Access Compliance Report Public Rights-of-Way (Curb Ramps)

Intersection ID: 44916Main Street:FOX_POINT_DRCross Street:BERRYBROOK_LNLocation:NEADA ID: FB0AA2F1285ARamp Type:PerpInitial Pass/Fail:FailOverall Compliance:NoSeverity Score:22.5

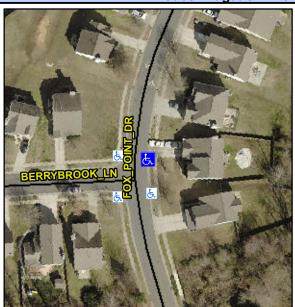
Possible Solutions:	Co
Remove & Replace Entire Ramp.	N/A
	No
	N/A
	N/A
	N/A
	N/A
Surveyor Notes:	N/A
N/A	N/A
	N/A
	N/A
	N/A
PROW/ADA:	N/A
R304.5.1, R304.2.2, R304.5.3	N/A
	N/A
	N/A
	N/A

Field Measurements/Component Compliance							
Compl	iance Description	Data	Comp	liance	Description	Data	
N/A	Ramp Length (in)	48.0	No	Ramp	Slope (%)	8.6	
No	Ramp Width (in)	45.0	No	Ramp	XSlope (%)	4.4	
N/A	Flare Type LT	N/A	N/A	Flare	Type RT	N/A	
N/A	Flare Slope LT (%)	N/A	N/A	Flare	Slope RT (%)	N/A	
N/A	Flare Traversable LT?	N/A	N/A	Flare	Traversable RT?	N/A	
N/A	Landing Length (in)	N/A	N/A	DWS	Provided?	N/A	
N/A	Landing Width (in)	N/A	N/A	DWS	Contrast?	N/A	
N/A	Landing Slope (%)	N/A	N/A	DWS	Length (in)	N/A	
N/A	Landing X Slope (%)	N/A	N/A	DWS	Full Width?	N/A	
N/A	Landing Curb? (Y/N)	N/A	N/A	DWS	Offset (in)	N/A	
N/A	Shared Landing?	N/A					
N/A	Gutter Ponding?	N/A	N/A	Gutte	Slope (%)	N/A	
N/A	Gutter Lip Ht (in)	N/A	N/A	Gutte	X Slope (%)	N/A	
N/A	Painted X Walk1?	No	N/A	Painte	ed X Walk2?	N/A	
	X Walk 1 Direction	To W		X Wal	k 2 Direction	N/A	
N/A	X Walk 1 Width (in)	N/A	N/A	X Wal	k 2 Width (in)	N/A	
	X Walk 1 Slope (%)	0.6		X Wal	k 2 Slope (%)	N/A
